CHAPTER V

Master Responses to Comments on the Draft EIR

Kaiser Permanente Oakland Medical Center Replacement Project

FIGURE 20

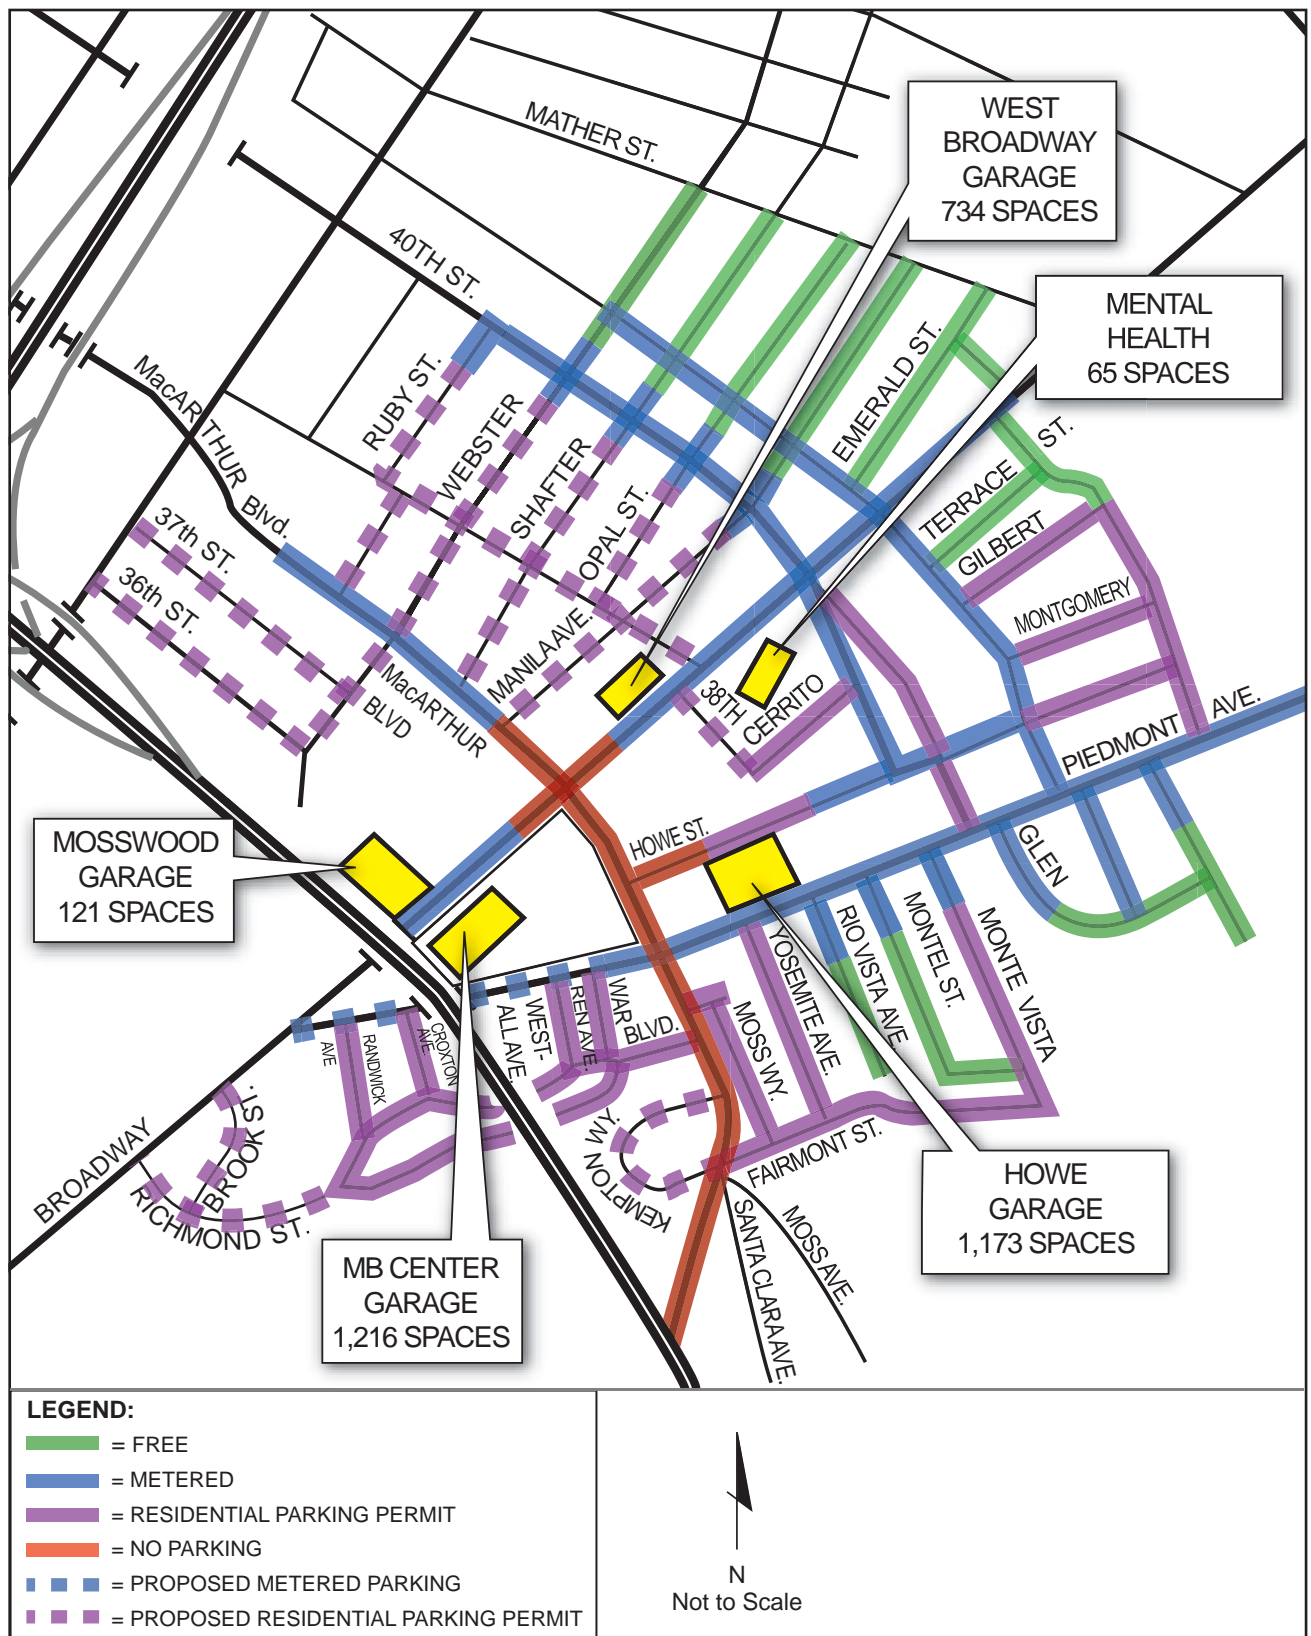
Also, the Final Transportation Impact Analysis prepared for the project included a figure entitled Future Kaiser Permanente Parking Facilities and On-Street Parking Designations (**Figure 20**), which would have supported the discussion of *Parking Facility Operations and Recommendations* on Draft EIR page IV.B-70, but this figure was inadvertently omitted from the Draft EIR. **Figure 20** is included on the following page of this Final EIR document. Also, the following bulleted text shall be added to the list of recommended parking improvements for consideration during project review:

- Kaiser shall fund an expanded Residential Parking Permit (RPP) programs in the residential neighborhoods surrounding the existing Medical Center east of Broadway and north of MacArthur Boulevard and the Richmond neighborhood south of MacArthur Boulevard. The RPP restricts on-street parking by non-residents to less than two hours during the weekdays. Kaiser funding is to be used for establishment efforts needed to create or expand the RPP area, as well as increased enforcement and maintenance of the program.
